PHAP13-00034

Date: November 18, 2013
Application Type: Certificate of Appropriateness
Property Owner: Martin Building LLC
Representative: Lane Gaddy and Tyler Daniels
Legal Description: 4 Mills 60 ft. on Mills X 112 ft. on N. Stanton & Adj. 12 ft. X 60 ft. to Aly Nec. (7440 sq. ft.), City of El Paso, El Paso County, Texas
Historic District: Downtown
Location: 215 N. Stanton Street
Representative District: #8
Existing Zoning: C-5/H (Commercial/Historic)
Year Built: 1917
Historic Status: Landmarks
Request: Certificate of Appropriateness for the rehabilitation of the subject property
Application Filed: 11/4/2013
45 Day Expiration: 12/19/2013

ITEM #4

Certificate of Appropriateness for the rehabilitation of the subject property

SIGNAGE

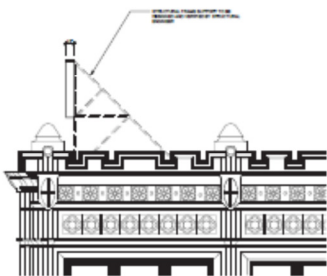
The modifications are that the new awnings/canopies be placed either at the top or bottom of the transom/signband and mounted so that they will not obscure, damage, destroy or alter significant architectural features; that a different location for the new lighting at the entryway be considered that does not have to be mounted into the terra cotta; that the new signs will be installed in their previous

locations so that the terra cotta building fabric will not be altered, damaged, or destroyed; and that the owner/architect shall propose a new building material instead of EIFS in the entryway.
